Project: **La Selva Beach Main
Replacements, Phase III**

CWO No.: **07-126**

Addendum No. 1

ADDENDUM 1. TIE IN REVISION AT ALTIVO AVE. AND LOMA AVE.

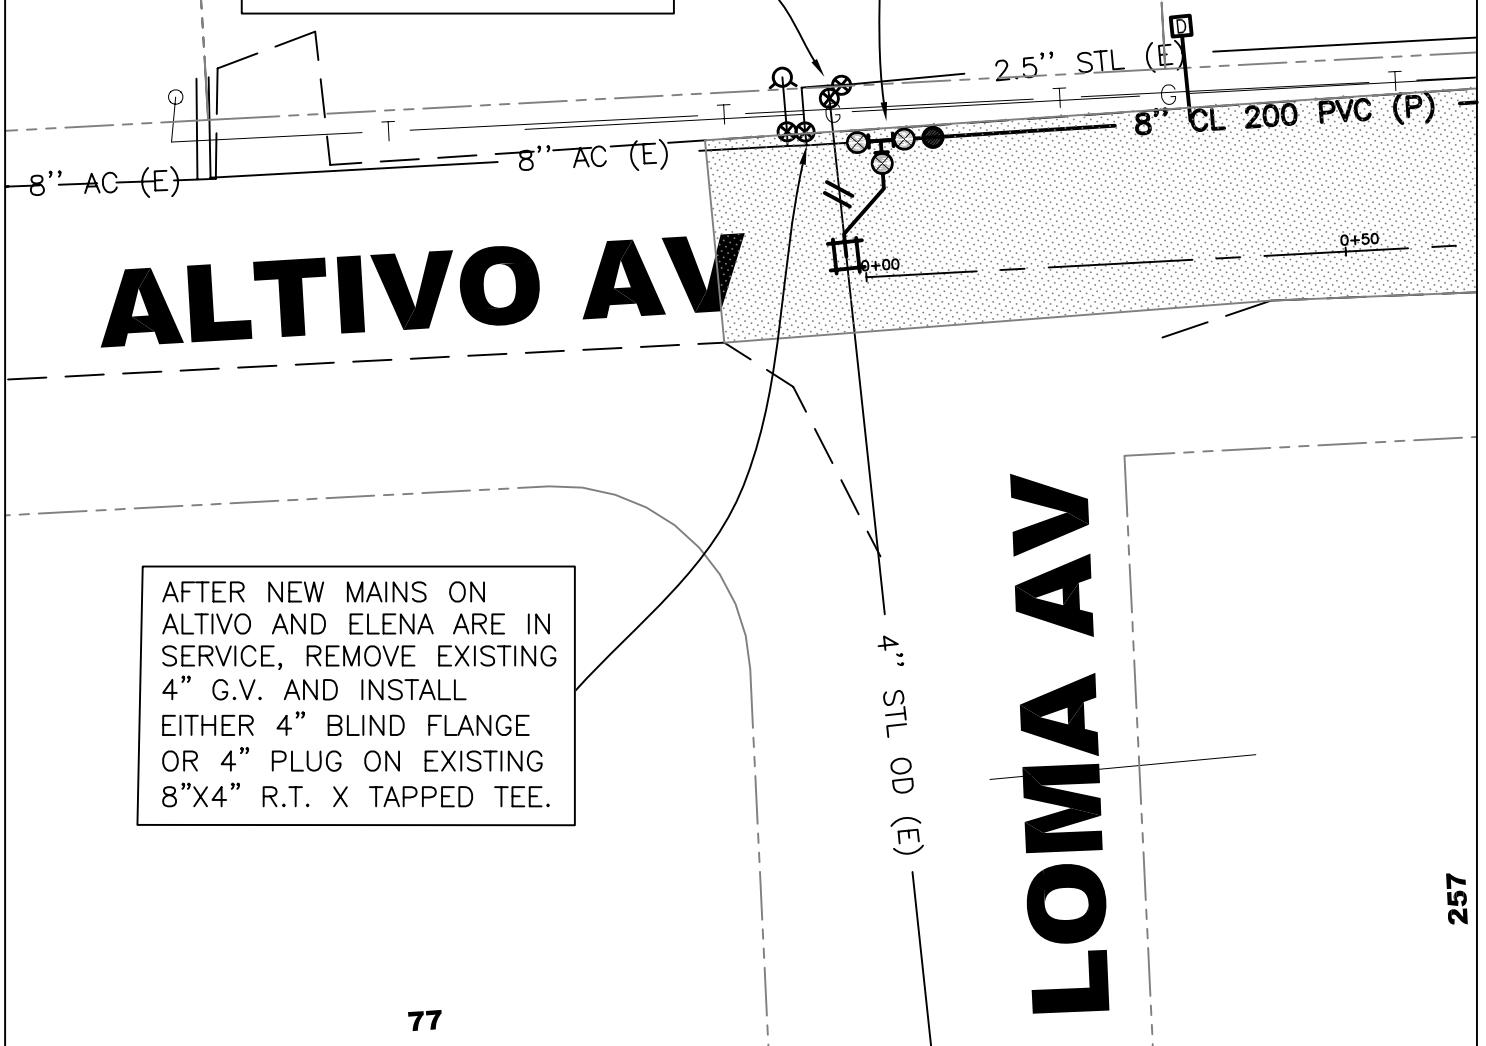
- Tie-in detail at Altivo Ave. and Loma Ave. has changed. Attached drawing shall replace tie-in detail on 24 x 36 plans.

LOCATION OF GAS LATERAL UNKNOWN. CONTRACTOR SHALL DETERMINE LOCATION BEFORE EXCAVATION.

TIE-IN AT ALTIVO AVE. AND LOMA AVE. INSTALL:

- (1) 8" TRANSITION COUPLING ON EXISTING AC STUB OUT
- (1) 8"X 6" FLG. TEE.
- (2) 8" FLG. X M.J. G.V.
- (1) 6" FLG. X M.J. G.V.
- (1) 6" X 4" M.J. REDUCER
- (2) 4" 45° ELBOW, M.J.
- (1) 4" TRANSITION COUPLING TO TIE INTO EXISTING 4" O.D. STEEL MAIN ON LOMA AVE.
- THRUST BLOCKS AS NECESSARY
- (40) L.F. 8" PVC MAIN LINE FOR THRUST RESTRAINT ALONG ALTIVO AVE.
- (1) CHLORINATION TAP PER S-23.

AFTER NEW MAIN IS IN SERVICE, ABANDON EXISTING VALVES FEEDING 2½" & 4" O.D. STEEL MAINS.

AFTER NEW MAINS ON ALTIVO AND ELENA ARE IN SERVICE, REMOVE EXISTING 4" G.V. AND INSTALL EITHER 4" BLIND FLANGE OR 4" PLUG ON EXISTING 8"X4" R.T. X TAPPED TEE.
